Apalis iMX8

Errata Document

Figure 1. Location of C267 (top side, top view)

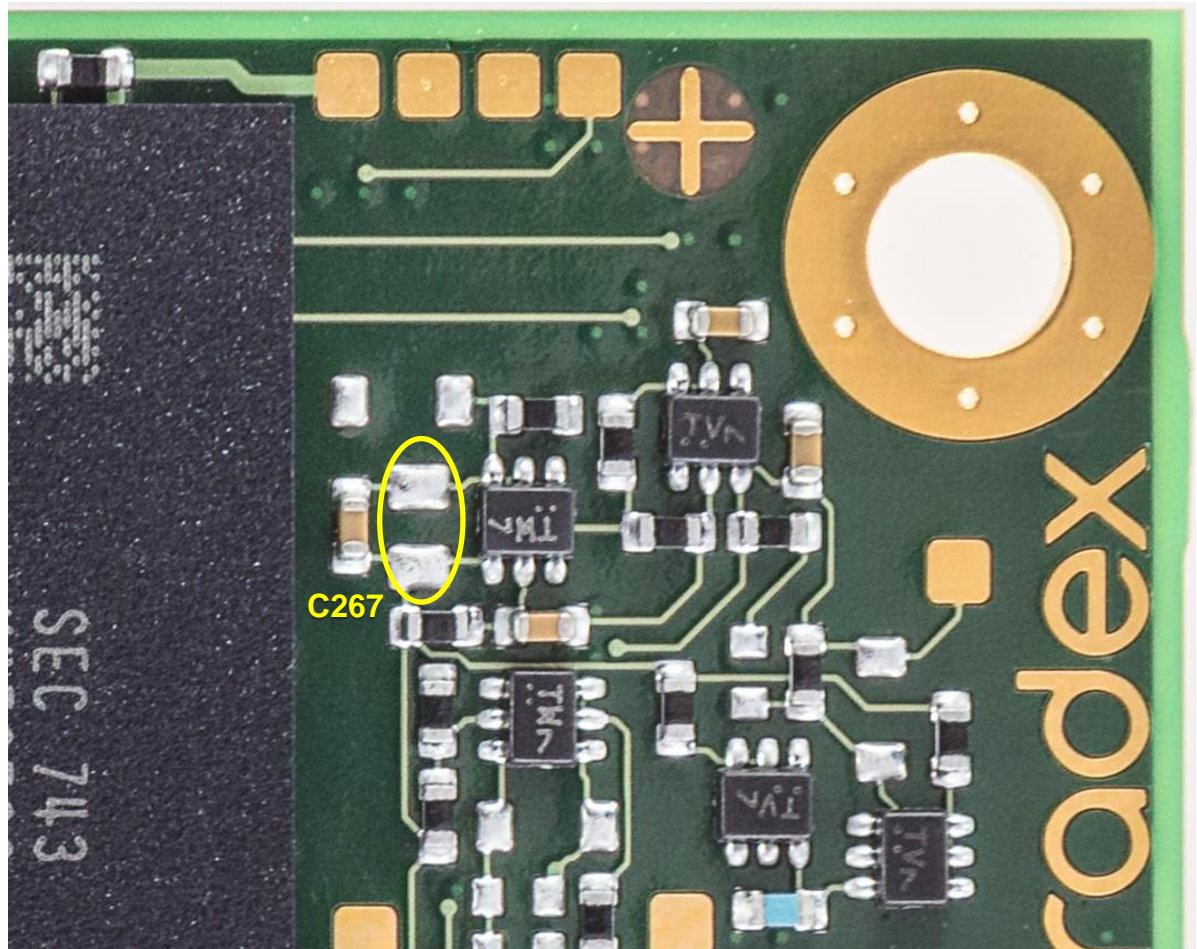
Unfortunately, the power button pulse that is generated is too short. The SoC does not get out of the power-off state, and therefore the PMIC is not turned on. The module does not start if the RTC rail is retained during the main voltage power cycle (VCC). The module can also not be started by pressing the reset button (RESET_MICO#). The only way to start the module after the PMIC is put to power-off is to remove the RTC rail together with the main module rail.

Option 2: Assemble C267 for making the power button signal pulse long enough. The capacitor C267 is not assembled on Apalis iMX8 modules with version 1.1A or older. By assembling C267 with a 10µF 6.3V capacitor with the 0603 size. The power button signal pulse gets its required duration. This means the module can be turned on either by power cycling VCC or by pressing the RESET_MICO# button
